Corrigendum 2 dated Mar 18, 2015 to Tender Specification BHEL PSSR SCT 1580

C) Some of the bidders had raised queries in the published tender specification. The Clarifications issued by BHEL are furnished below:

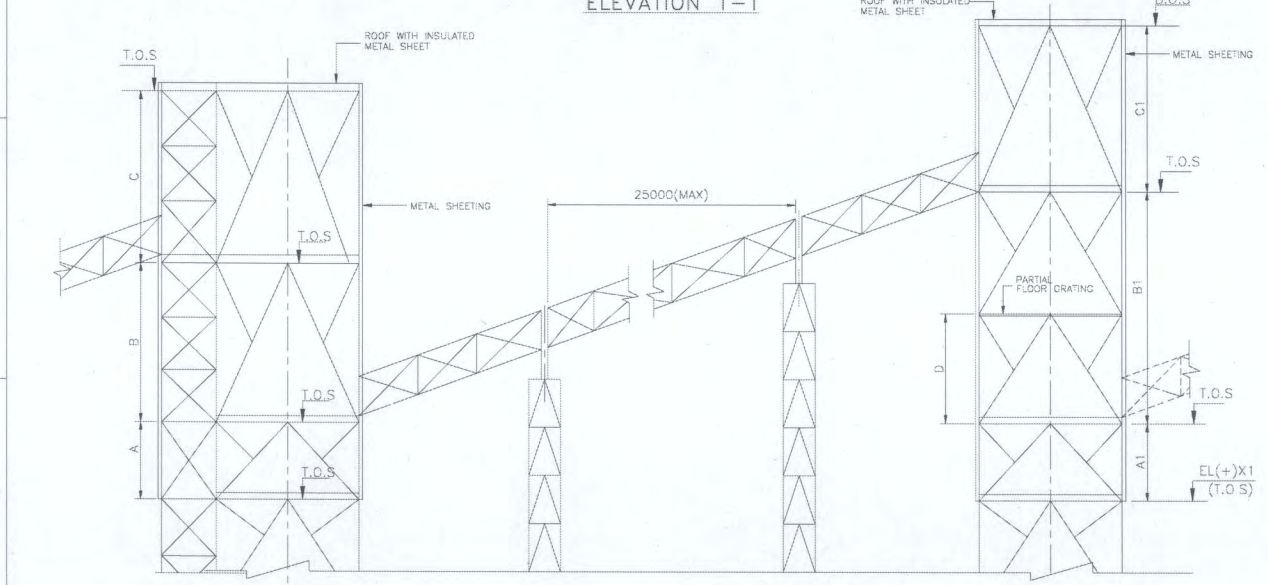
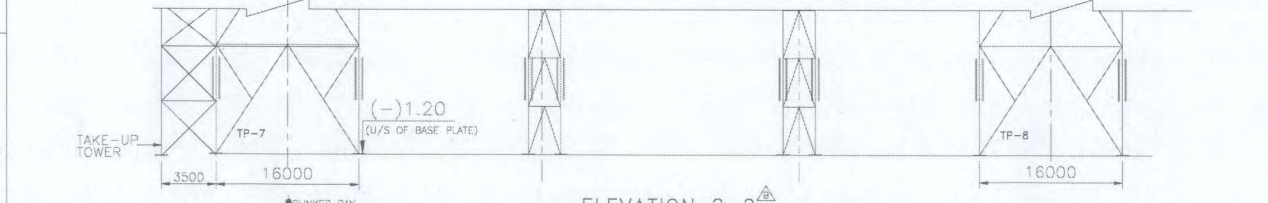
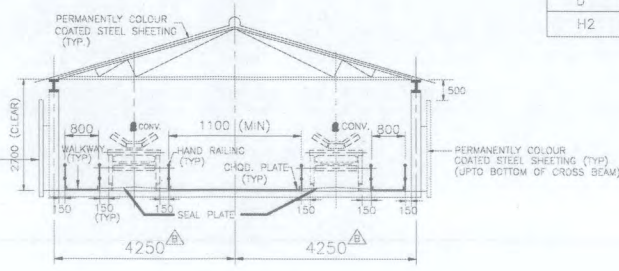
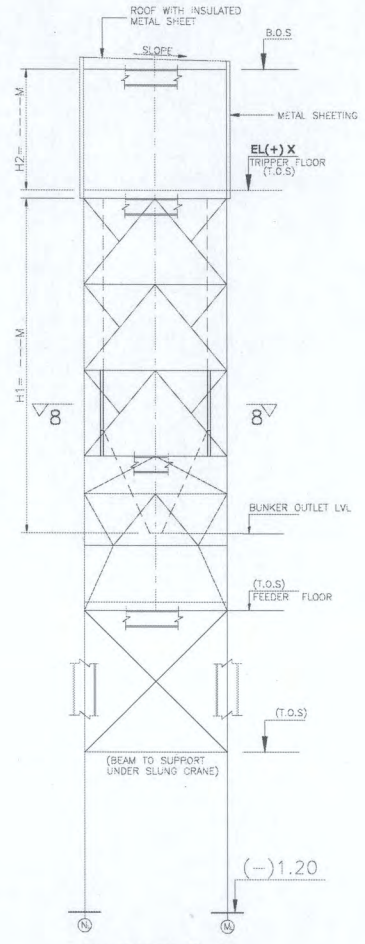
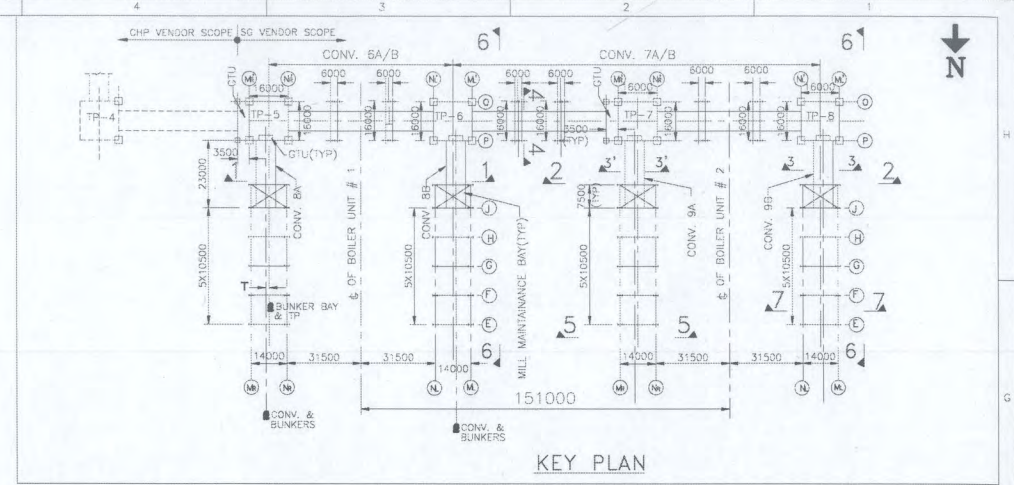
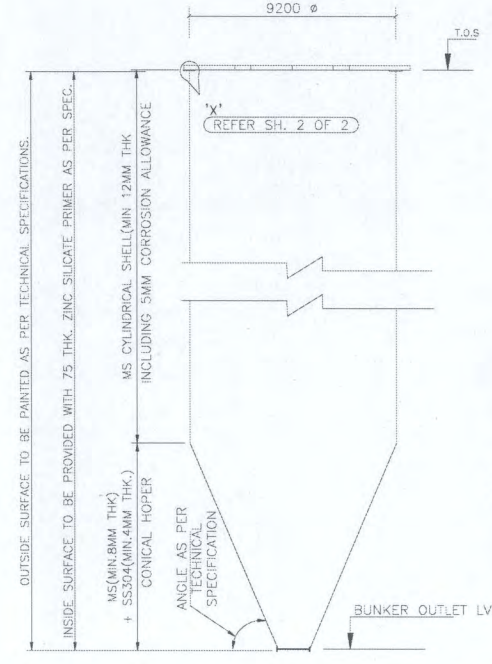
5)			Provide the structural drawings for sheeting works for the subject work.	Drawing will be made available only during detail Engineering Stage.
6)	TCC Volume IA, Part-I, Chapter – II SCOPE OF WORKS Clause No. 1.2.8	The terminal points can be inferred from the relevant appendices / annexures..... instructed by BHEL Engineer, with in the quoted rate.	The terminal points can be inferred from the relevant appendices / annexures (scope of work) and any further clarifications..... Please provide the terminal points for Transfer points, Trestles and conveyor galleries.	Drawing no 9549-102-POC-A-001 (2 sheets) provided in the last few pages of this corrigendum is for information.

Surface condition	Title	Assy. no.
All dimensions are in m.m. unless specified	GENERAL ARRANGEMENT OF RACK & PINION ELEVATOR	Ref. dng. no.
Product	P. O. No.	Scale N.T.S.
ELEVATOR	BHEL / PSSR / PUR / C - 17201 Dtd - 06 / 03 / 2008	Replace
Code no.

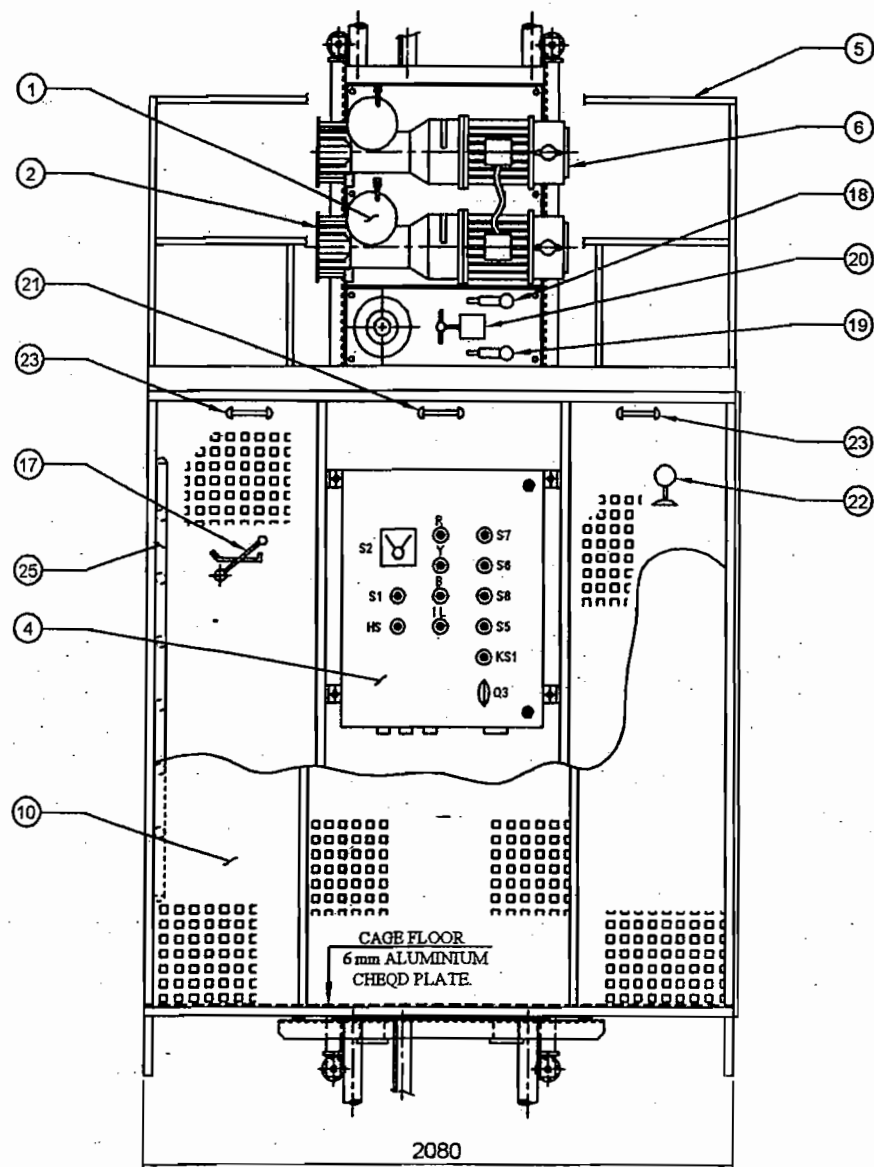
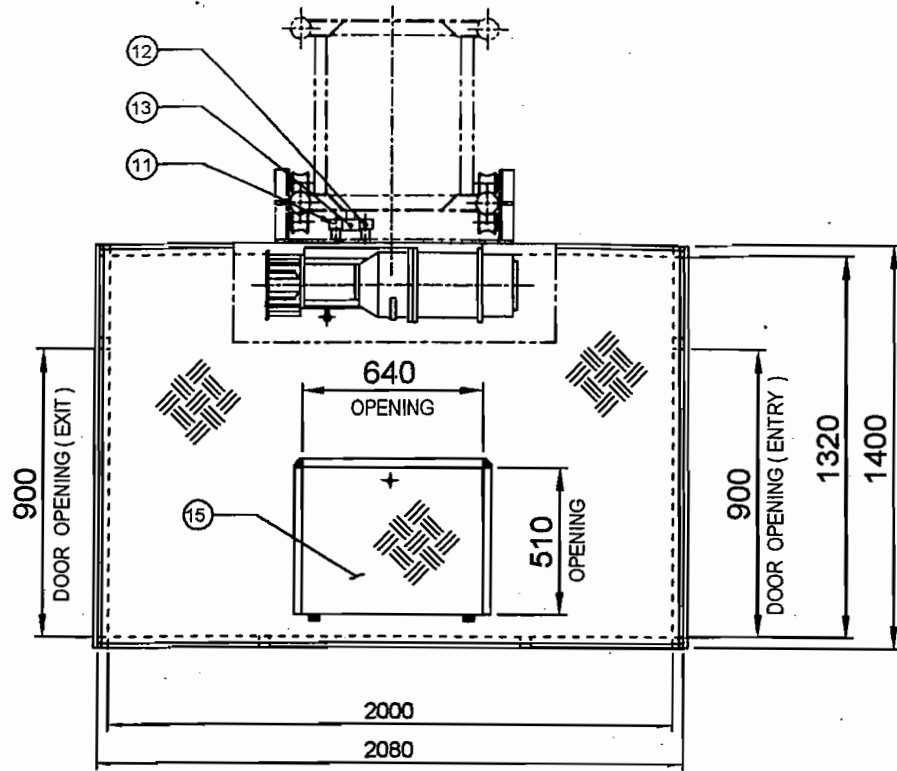
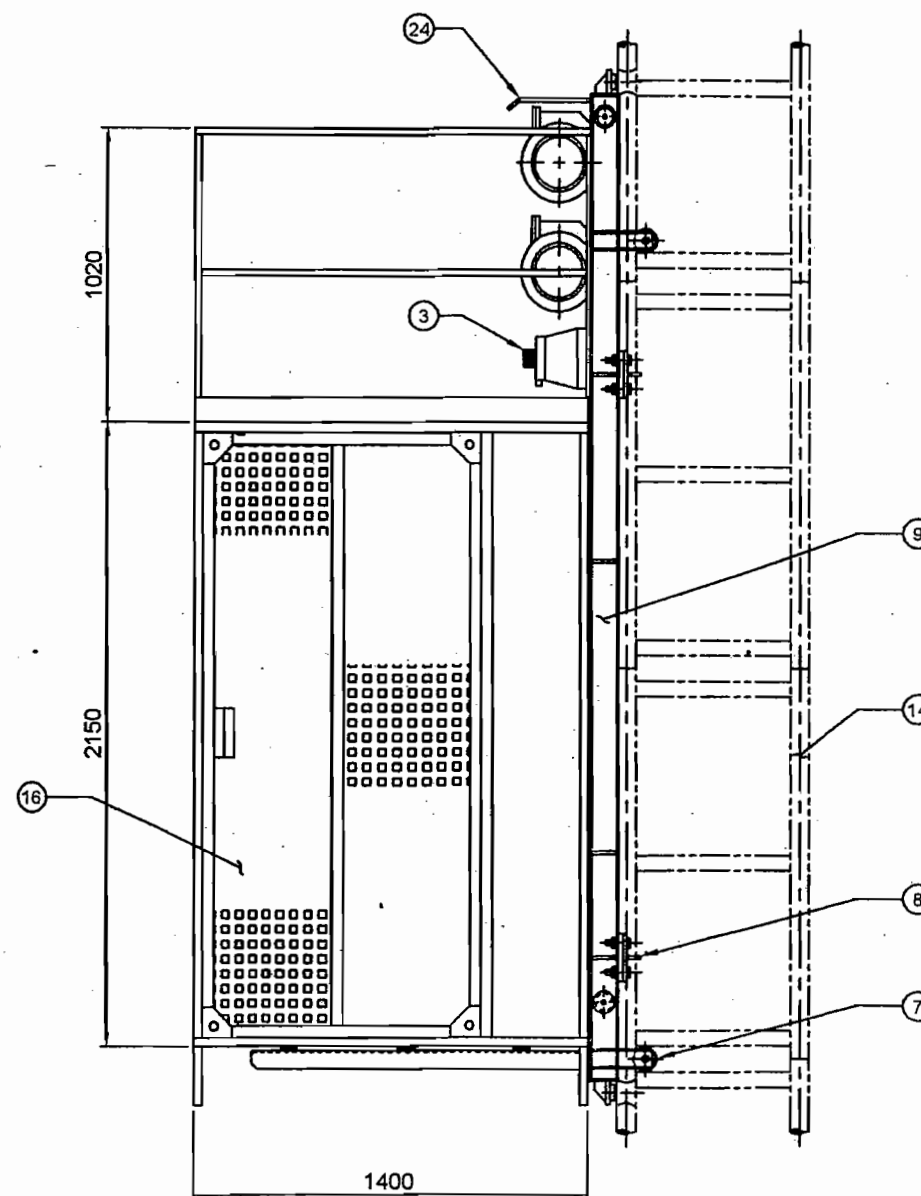
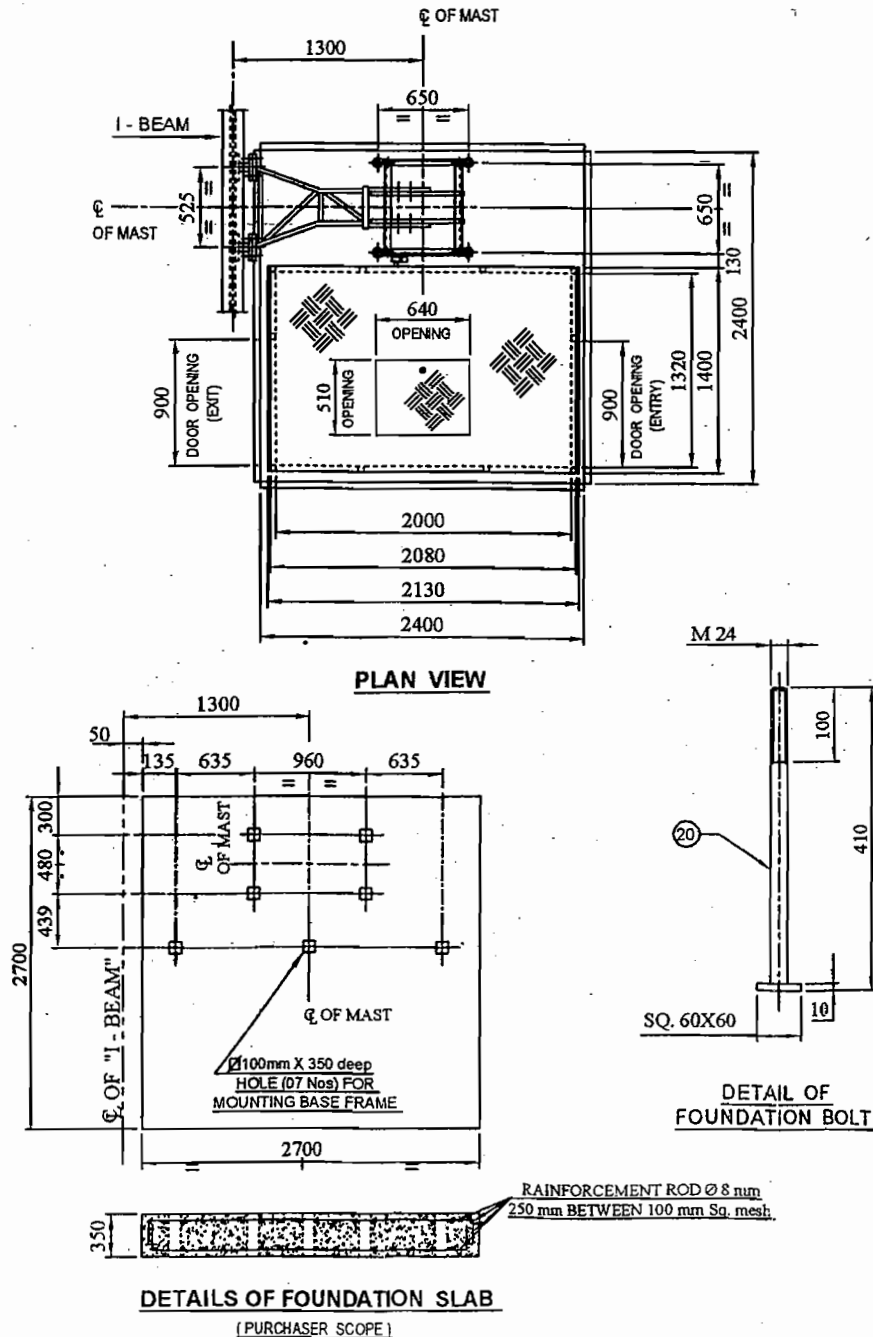
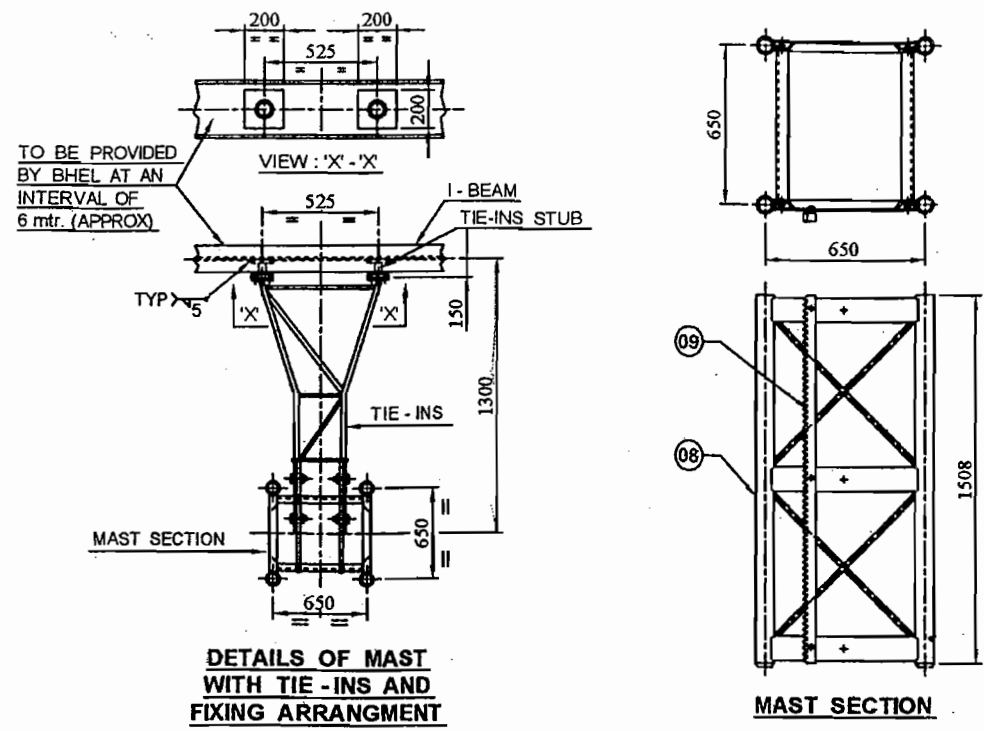
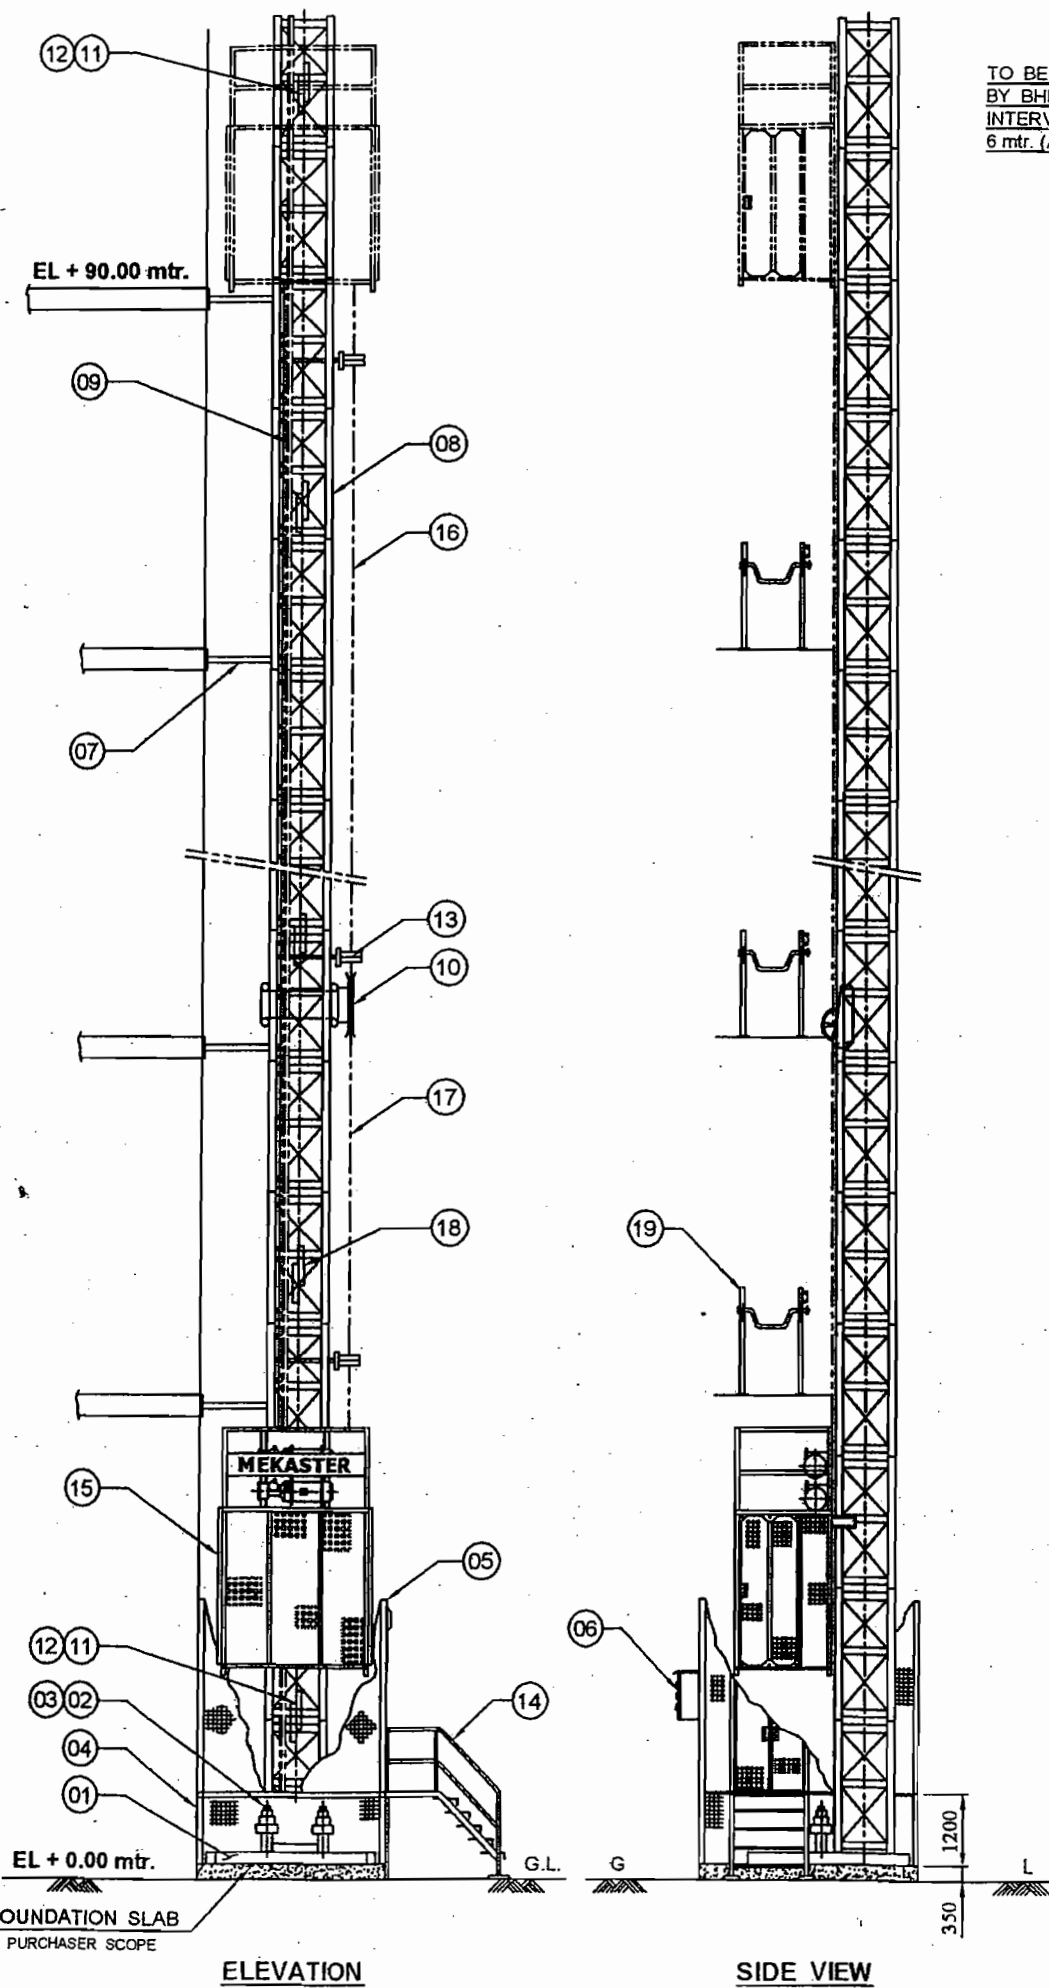
<u>No</u>	<u>Reference clause</u>	<u>Existing provision</u>	<u>Bidder's query</u>	<u>BHEL's clarification</u>
27)	TCC Volume IA, Part-I Chapter - XIV ERECTION Clause No. 1.14.2.55	The civil foundation for passenger cum goods lifts (temporary lift) shall be provided by BHEL . The contractor has to erect the passenger cum goods lifts including civil foundation , as per instructionwhichever is earlier. Foundation drawing for the proposed passenger lifts is enclosed for information.	In first line, the foundation for passenger cum goods lift shall be provided by BHEL however in line third the civil foundation is in scope of contractor, please clarify.	The civil foundation for passenger cum goods lift is in the bidder's scope. Drawings on General arrangement (two sheets) and Foundation (one sheet) for the proposed passenger cum goods lift provided in the last few pages of this corrigendum are for information.
